ATTACHMENT NO. 5

**Re: Brick and Machine Project - 9735 Washington Boulevard
Comments on The Project and Proposed Mitigated Negative
Declaration**

Figure 1. Potentially Impractical/ Infeasible Construction Logistics Based on Revised Mitigation Measure NOISE-3

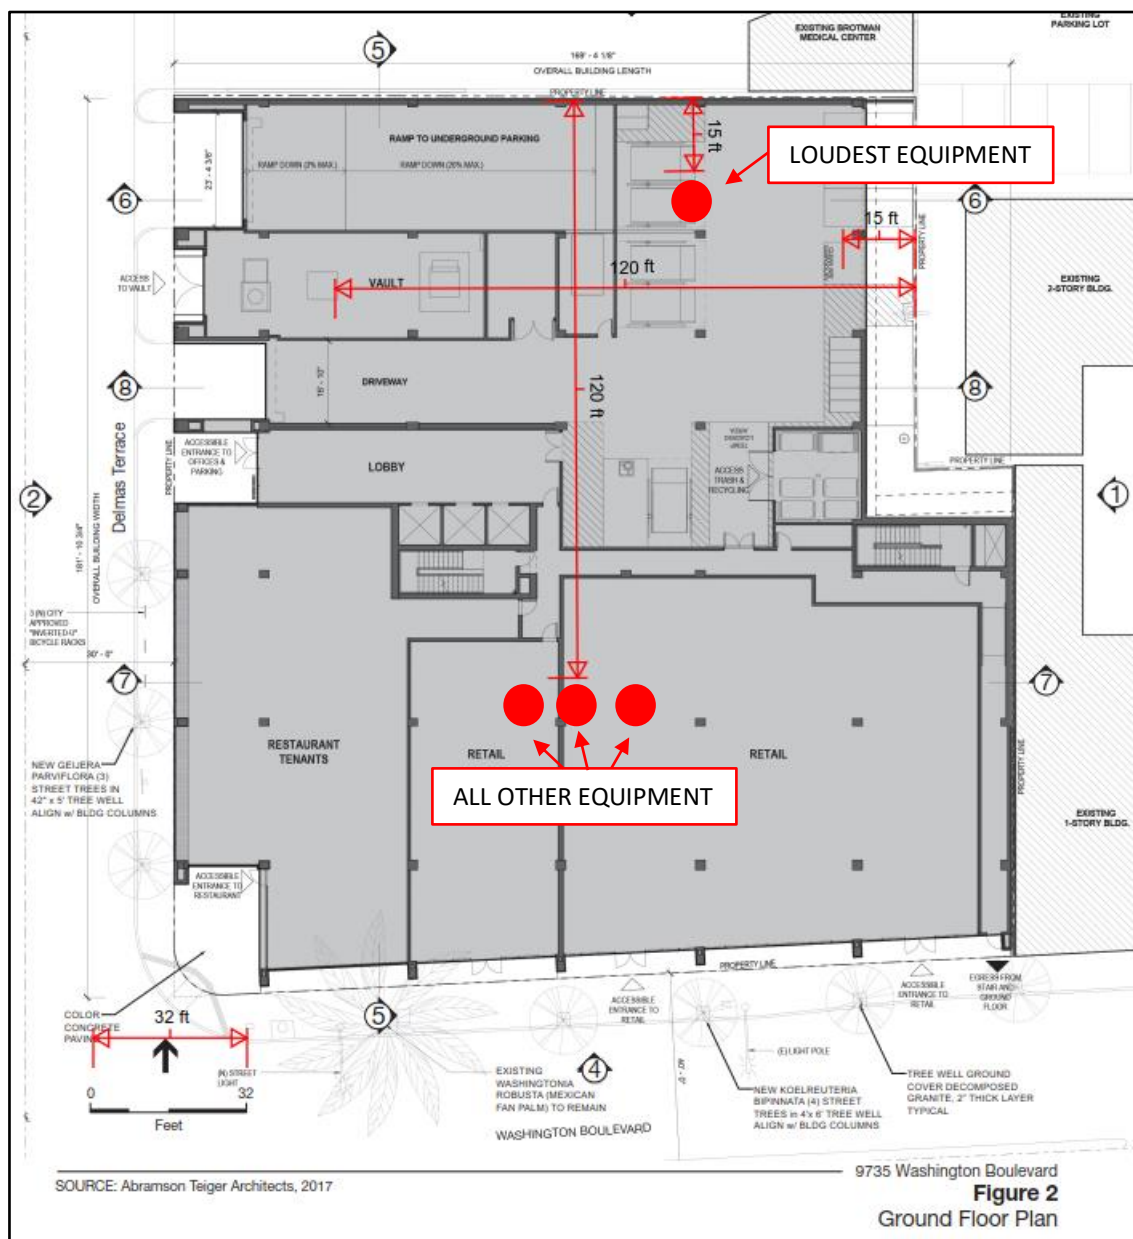
The first, second, and fourth sentences of the fourth paragraph of the response to Comment 14 state, "Mitigation Measure NOISE-3 requires that the simultaneous operation of multiple pieces of equipment be avoided. The mitigation measure has been modified to specifically allow no more than one piece of noise-generating equipment at a time to operate within 15 feet of the adjacent hospital and residential use. All other noise-generating equipment must be operated no closer than 120 feet of the adjacent hospital and residential uses."

These work activity distances/construction logistics are normally impractical and infeasible to construct the proposed project. The City of Culver City Noise Element states that noise level standards are in reference to the property line of the noise sensitive receptor. Please see Figure 1 for an example illustration, utilizing the proposed project design documents, of equipment locations based on revised Mitigation Measure NOISE-3, noted to scale. Furthermore, what are the projected, resulting noise levels due to equipment located just outside of the 15 feet distance threshold? Several pieces of construction equipment located at 16 feet from the property line of the hospital or the nearest residence could result in noise levels well above 91 dBA Leq.

Additionally, the revised construction noise analysis is described incorrectly in the fourth paragraph of the response to Comment 14 as the fifth sentence states, "As shown in the calculations below (page 13), assuming that the loudest piece of equipment during each construction phase would be operating at 15 feet from sensitive receptors.," yet the revised calculations feature the loudest piece of equipment at a distance of 15 feet from the sensitive receptor in only 3 out of 6 work phases analyzed. The construction noise calculations need to be revised to support estimated noise level claims.

If the noise analysis and mitigation measures have been revised from the original content contained within the IS/MND, then the IS/MND requires formal revision to reflect these changes to support the conclusions within the revisions presented. The revised Mitigation Measure NOISE-1 on page 14 on the Responses to Allen Matkins Letter should be amended to clearly define the distinctions between equipment noise due to engine combustion (mitigatable via noise control devices) and equipment noise due to operational use. One example revision may be, "...achieving a minimum of 10 dB reduction in equipment noise due to internal combustion engine noise." Additionally, revised Mitigation Measure NOISE-3 should be amended to address noise impacts
